City of Dublin Architectural Review Board

Planning Report

16 North High Street Multi-Tenant Sign Plan

Agenda Item	1
Case Number	11-002ARB
Proposal	A multi-tenant sign plan for an existing retail building located in the Historic Business District.
Request	Review and approval of sign modifications under the provisions of Code Section 153.070 and the <i>Historic Dublin Design Guidelines</i> .
Site Location	16 North High Street.
Owner/Applicant	John Kilbury, property owner.
Representative	Mark Greiwe, owner of Cruise One.
Case Managers	Alexis Dunfee, Planning Assistant Eugenia M. Martin, ASLA, Landscape Architect (614) 410-4600; adunfee@dublin.oh.us, emartin@dublin.oh.us
Planning Recommendation	Approval with 2 Conditions.

Primary Identification Signs: Wall Sign

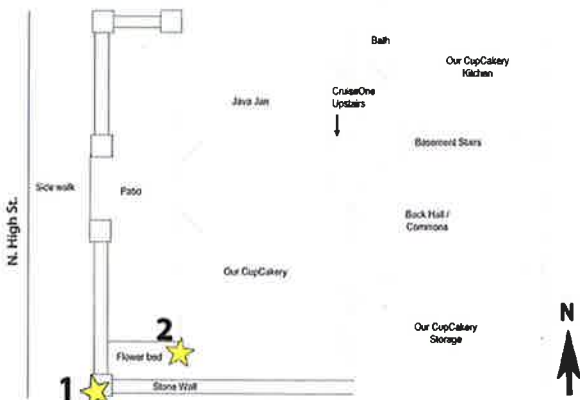
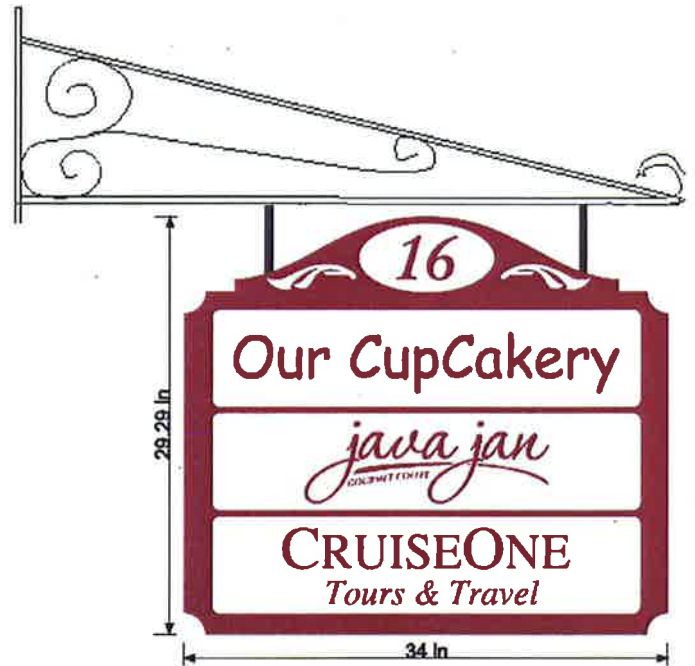
Details	Sign Modifications
Front Wall Sign	<p>The applicant is proposing to add a one-square-foot panel directly below the existing five-square-foot 'Our CupCakery' sign. This would meet the <i>Guidelines</i> which permit a maximum sign size of six-square-feet, regardless of the number of tenants. The additional sign panel is to be constructed of a sand-carved HDU material. The proposed colors and font are consistent with the existing tenant signs; white Caston Bold letters with a maroon background. The applicant has not indicated how the sign will be mounted or attached.</p>
Projecting Multi-Tenant Sign	<p>The applicant is proposing a projecting multi-tenant sign, with two different options for locations. Both options have a two-sided six-square-foot maroon sign face, with 6.75-inch by 30-inch aluminum polymetal tenant panels with a white background and maroon letters.</p> <p><i>Option #1</i> consists of a ground mounted two-sided aluminum projecting sign with panels for each tenant. The sign would be attached by an iron mounting bracket painted brown to match the existing trim on the building. The post for the sign is 84-inches high and would be located approximately five feet from the High Street right-of-way on the south side of the patio stone wall. Code states that ground signs must be located eight feet from right-of-way.</p> <p><i>Option #2</i> consists of a wall mounted two-sided aluminum projecting sign with panels for each tenant. The sign would be attached to an iron mounting bracket painted brown to match the existing trim on the building. This sign is proposed to be mounted on the southwest corner of the front of the building.</p> <p>The addition of a multi-tenant projecting sign with the current wall signs is not permitted by Code. The approval of the multi-tenant projecting sign would require the removal of the two existing wall signs.</p> <p>It is Planning's recommendation that the one-square-foot wall sign be approved as it is more consistent and appropriate to the existing signs on the structure and overall sign design. Further, the ground mounted sign is not permitted by the Zoning Code and would require a variance from the Board of Zoning Appeals if sanctioned by the ARB.</p>

6) Complementary Sign Design Condition 2	Criterion met with conditions: <i>Primary Identification Sign:</i> The applicant's proposal for two primary identification signs is not permitted by the Zoning Code. The proposed front wall sign is consistent and appropriate to the existing signs on the structure. The multi-tenant ground sign is not consistent with the overall sign design and would require the other tenants to remove their existing wall signs. The applicant select the one-square-foot wall sign for their primary identification sign on the front of the building. <i>Secondary Identification Sign:</i> The rear identification sign is consistent with the overall existing sign design and is permitted by Code. The addition of a rear wall sign is an appropriate secondary identification for the entrance from the rear parking lot.

- 1) The mounting brackets for the wall signs be concealed; and
- 2) The one-square-foot wall sign be used as the primary identification sign on the front of the building.

Primary Identification Sign: Multi-tenant Sign

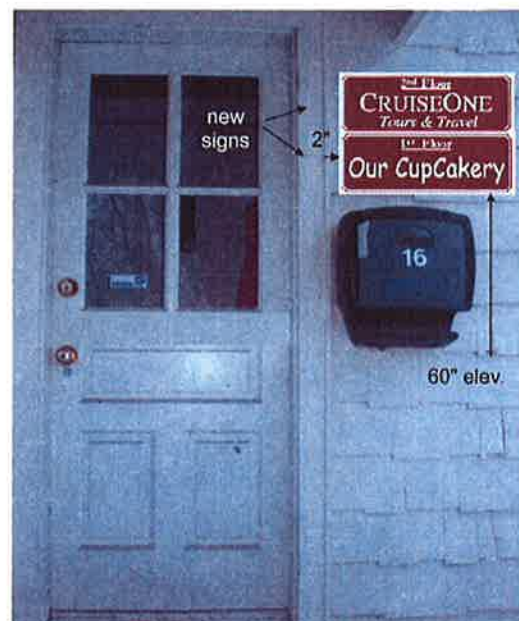
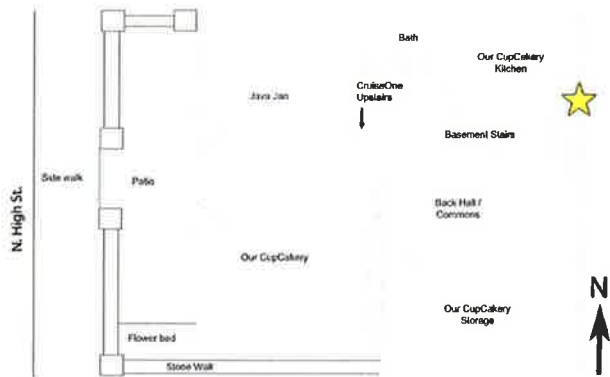
Primary Identification Sign	<p>The applicant is requesting the use of a wall sign and a ground sign along the front façade of the building; however, Code permits only one sign type.</p>
